Draft Memorandum

To: David Kliegman, Okanogan Highlands Alliance
From: Ann Maest, Stratus Consulting Inc.
Date: 7/2/2010
Subject: Comments on Kinross/Crown Resources June 24, 2010 Letter to the Washington Department of Ecology regarding the Action Plan for Observed Seepage in Gold Bowl Creek

Figure 1. Location map of the Buckhorn Mine area showing surface water and seep monitoring locations with increasing chloride concentrations in water year 2009.

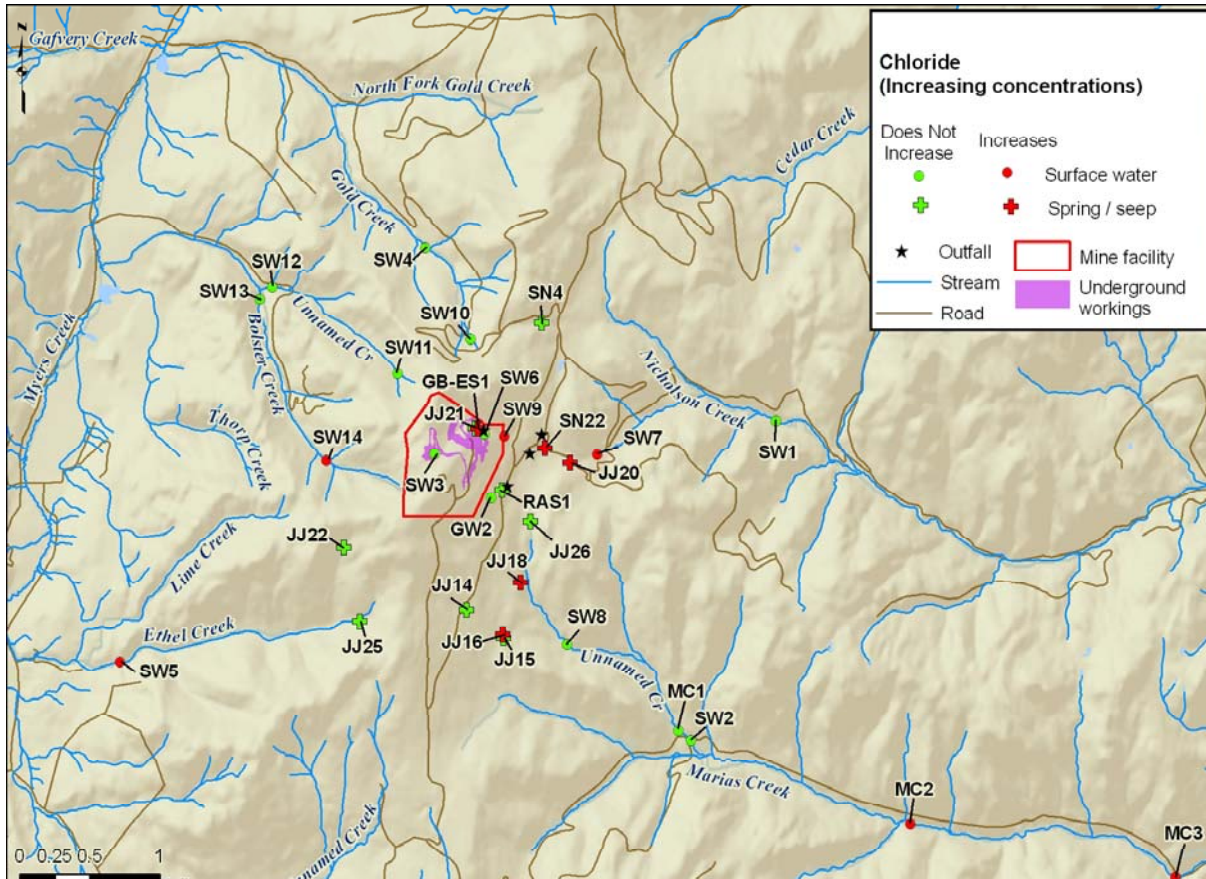
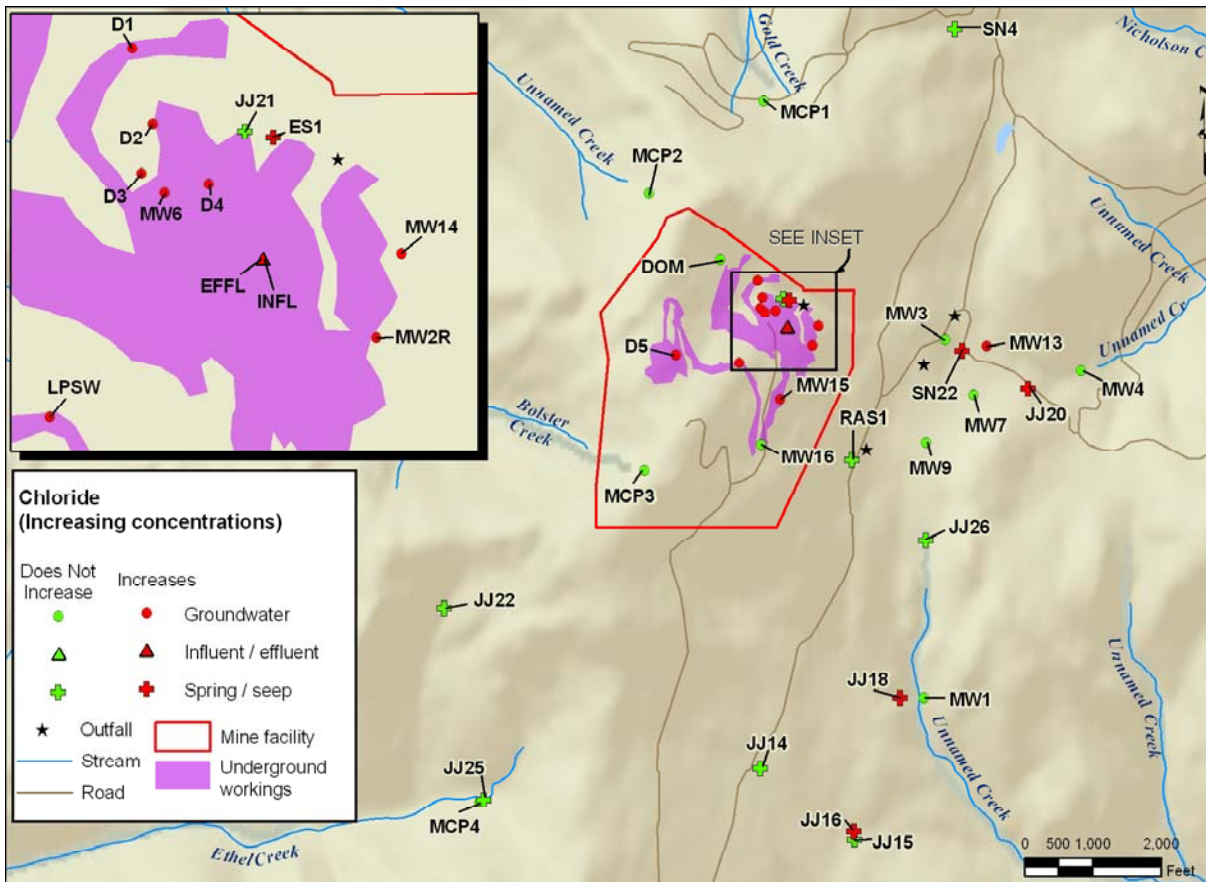
This memorandum responds to the Kinross/Crown Resources (Kinross) letter to the Washington Department of Ecology (DOE) regarding the action plan for observed seepage in Gold Bowl Creek (Crown Resources, 2010). According to the Buckhorn Mountain Adaptive Management Plan (AMP) for water quality (Golder Associates, 2007), if concentrations of mine-related contaminants exceed background levels or the National Pollutant Discharge Elimination System (NPDES) permit limits, Kinross must initiate an action plan to identify and eliminate the source of the problem (Golder Associates, 2007). Kinross noted in its June 24, 2010 letter to DOE that elevated total dissolved solids (TDS) and sulfate concentrations at SW-9 in Gold Bowl Creek had triggered the AMP. In addition to this location, concentrations of mine-related contaminants (nitrate, sulfate, and TDS) have also increased relative to baseline values at SW-7 (surface water location downstream of SW-9 in South Fork Nicholson Creek), MW-14 (monitoring well near lower portal), and in spring JJ-21 (spring in South Fork Nicholson Creek; Figures 1 and 2).

Figure 3. Increasing concentrations of chloride and nitrate in surface water locations SW-9 and SW-7. Vertical dashed line indicates the start of mining operations; vertical dotted lines indicates the beginning of water year 2009.

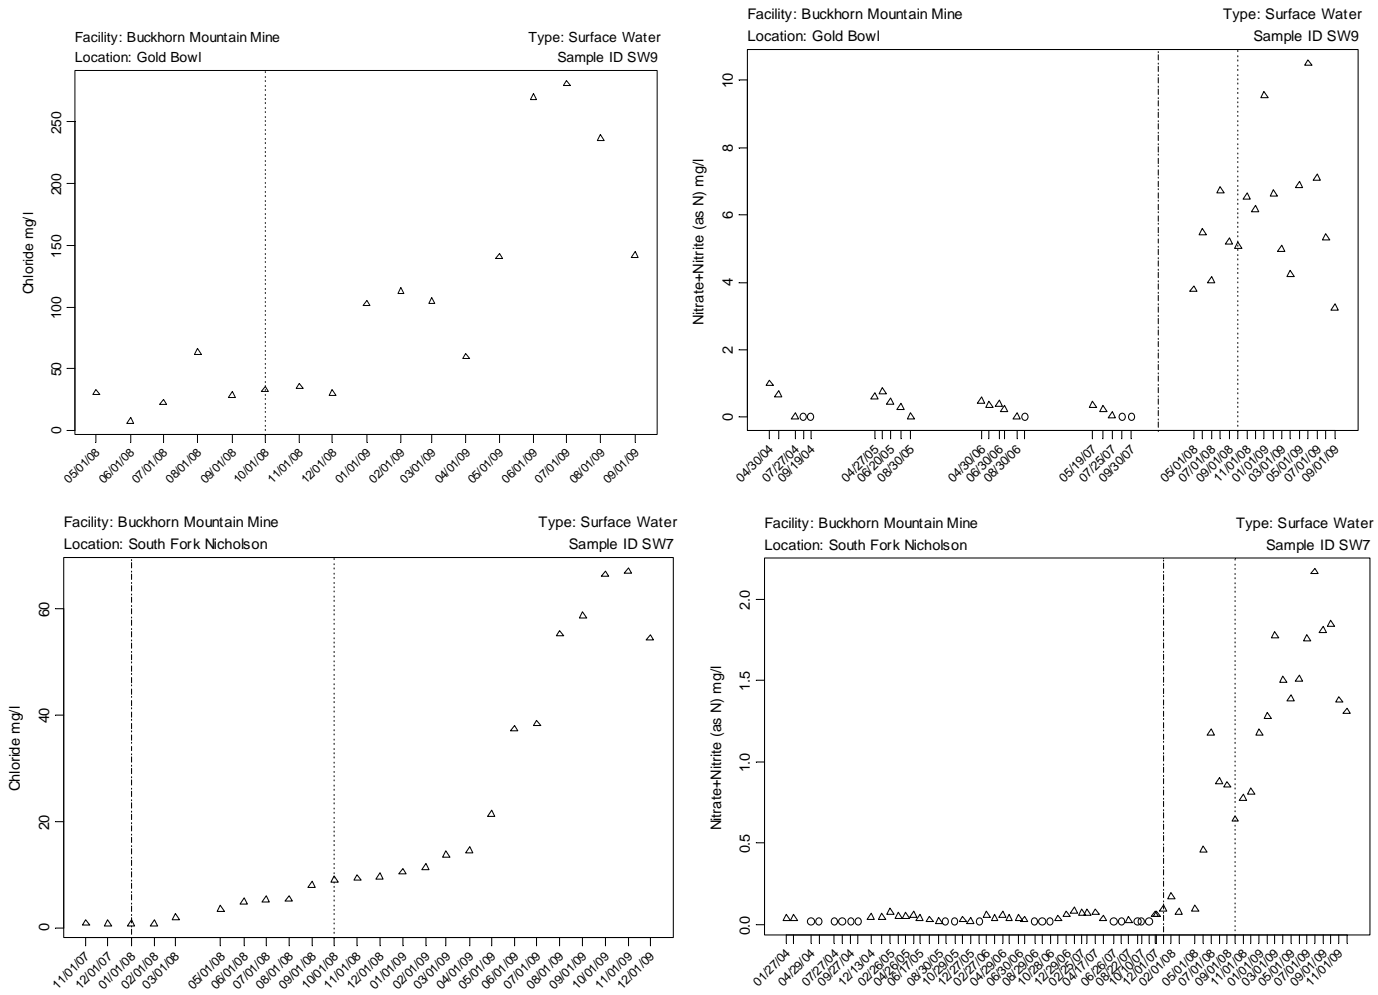
Although no State surface water standards have been exceeded at the SW-7 and SW-9 surface water locations, concentrations of mine-related contaminants have been increasing and pH has been dropping at these locations, mostly since late 2008. Figure 3 shows increasing concentrations of chloride and nitrate at SW-9 and SW-7 through water year 2009. Increasing chloride concentrations are from treated effluent that was either released at outfall 002 or stored in the underground mine. Nitrate concentrations at SW-9 and SW-7 showed an increase as early as May 2008 (samples are not collected in the winter months at SW-9, so the increase might have occurred even earlier). TDS concentrations at SW-9 and SW-7 did not increase notably until mid-2009. Sulfate concentrations peaked in mid-2008 at SW-9 and SW-7 (~160 and 70 mg/L, respectively) and had been decreasing, but have recently increased to 257 mg/L at SW-9 in May 2010. Field pH values may be decreasing at both SW-9 and SW-7 (since about late 2008).

Figure 4. Increasing concentrations of chloride, depth to water, sulfate, and nitrate in monitoring well MW-14.

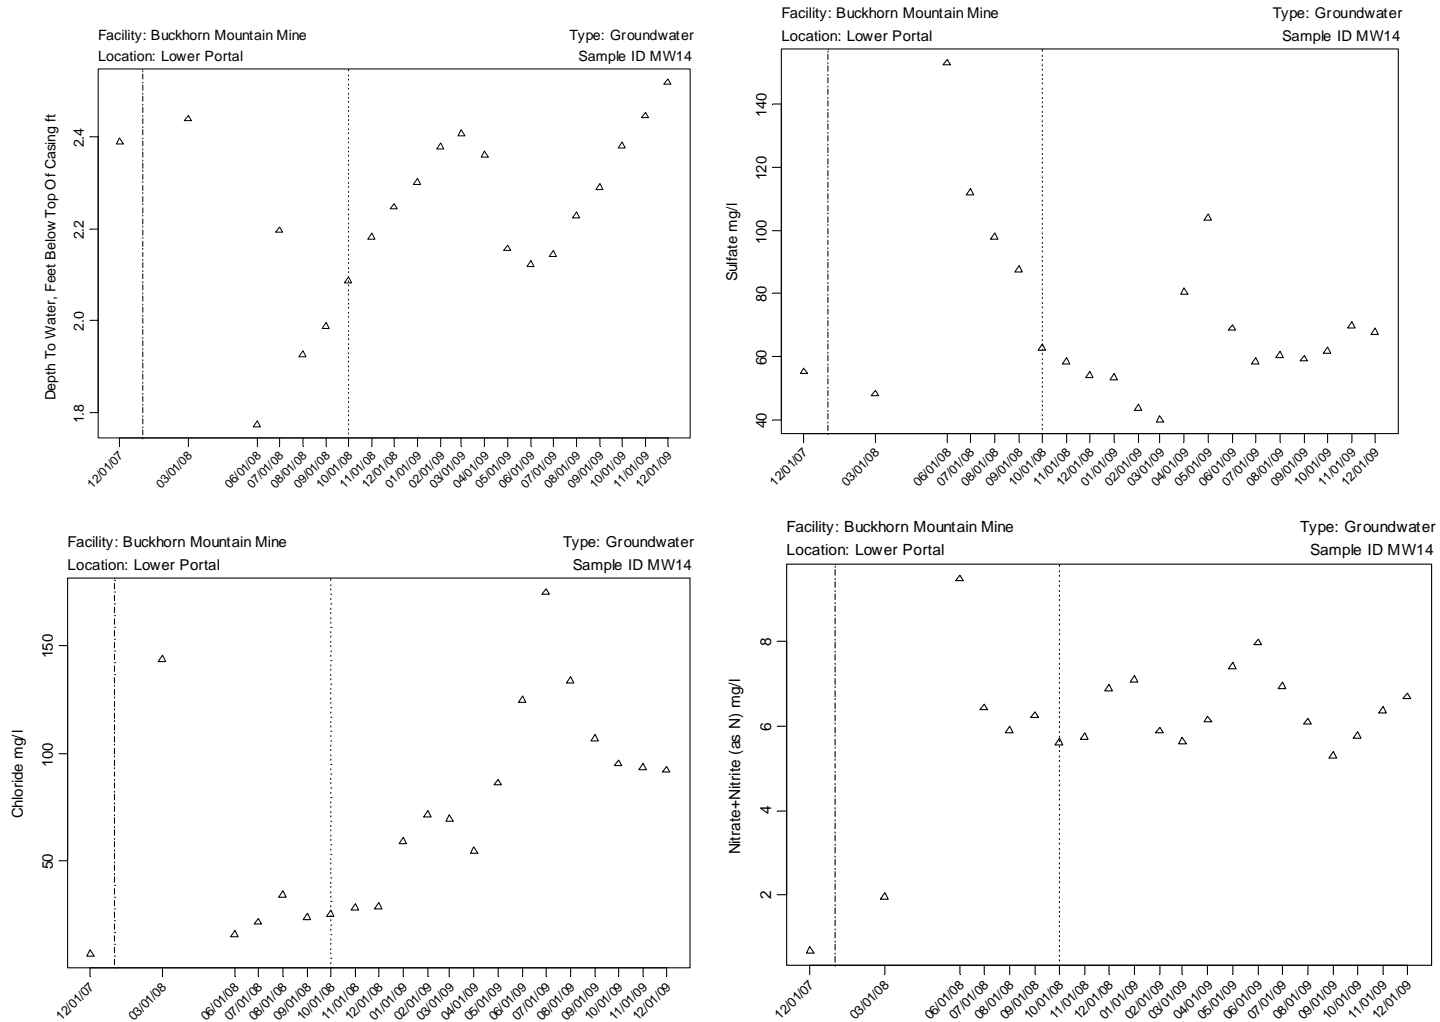
Concentrations in monitoring well MW-14 exceeded State groundwater quality standards for TDS, sulfate, and nitrate (State of Washington, 2010) in 2010, yet Kinross makes no mention of these exceedences in their letter. Concentrations of all three constituents have increased in 2010 over values in 2009, and values did not exceed standards before 2010. Figure 4 shows depth to water and increasing concentrations of chloride, sulfate, and nitrate in MW-14 through water year 2009. Concentrations in May 2010 were 696 mg/L TDS, 288 mg/L sulfate, and 10.5 mg/L nitrate+nitrate (mg/L as N). State standards for these constituents are 500 mg/L, 250 mg/L, and 10 mg/L, respectively.

Figure 5. Increasing concentrations of chloride and nitrate, decreasing pH values, and decreasing flows in seeps at the mine through water year 2009.

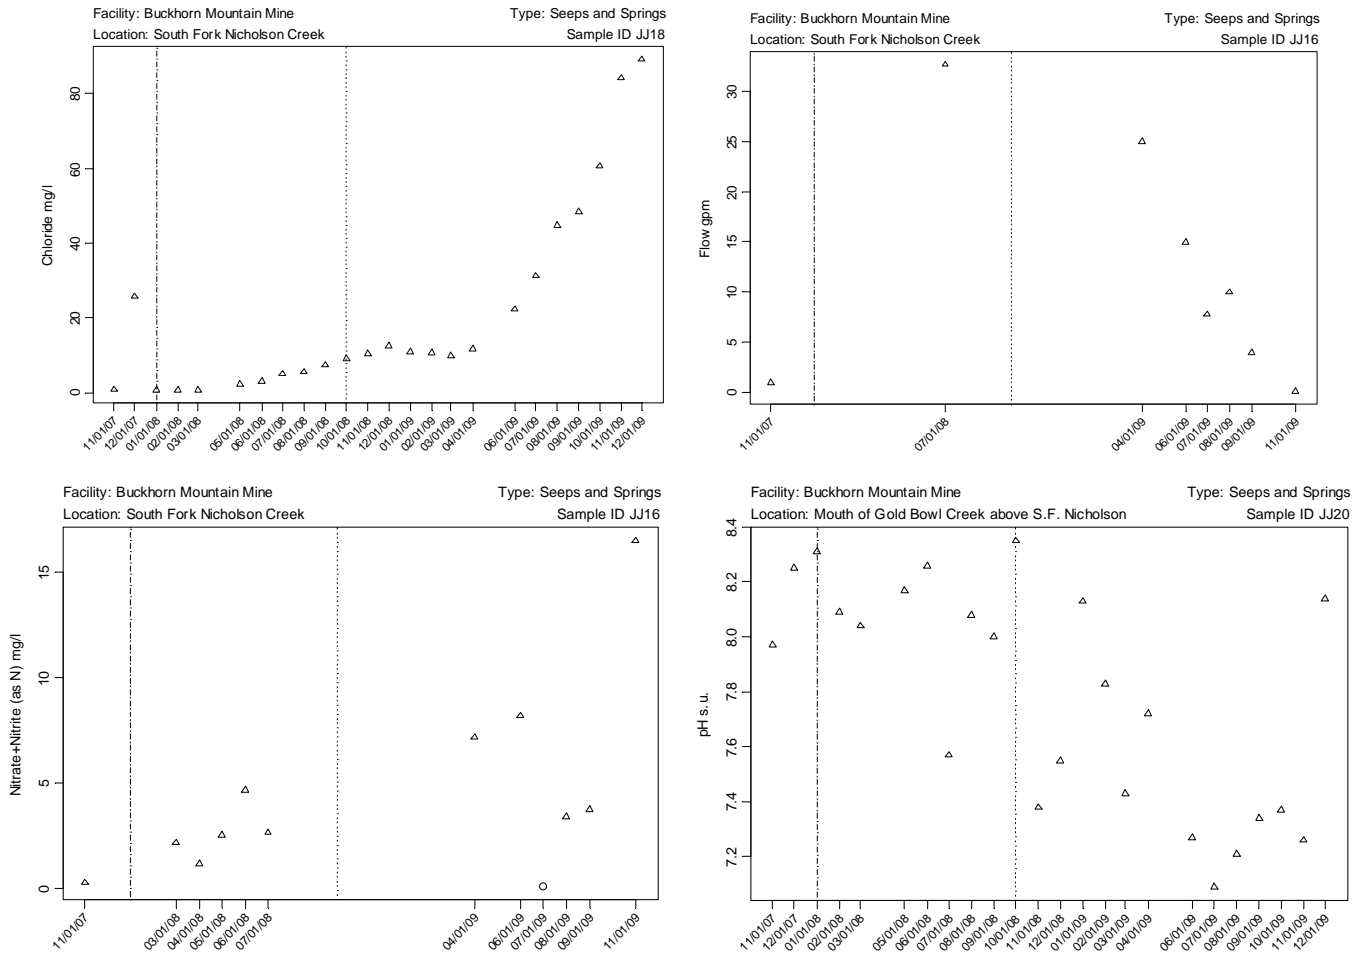
The Kinross June 2010 letter to DOE notes that concentrations of mine-related constituents have increased in spring JJ-21 and that flows have decreased. However, the letter does not note that concentrations have been increasing at other seeps in the mine area as well since mining began (dewatering began in January 2008). For example, concentrations of chloride, nitrate, and TDS have been increasing relative to pre-mining values at seeps JJ-21, JJ-16, JJ-18, SN-22, JJ-20, and RAS-1. Flows have decreased at JJ-20 and JJ-16 but increased at JJ-21; pH values have decreased at JJ-15, JJ-20, JJ-18, and SN-22. Figure 5 shows increasing concentrations of chloride, decreasing flows, increasing nitrate concentrations, and decreasing pH values in seeps at the mine through water year 2009. Nitrate concentrations in seep JJ-16 were higher than State groundwater or surface water standards (10 mg/L nitrate+nitrite as N) in water year 2009.
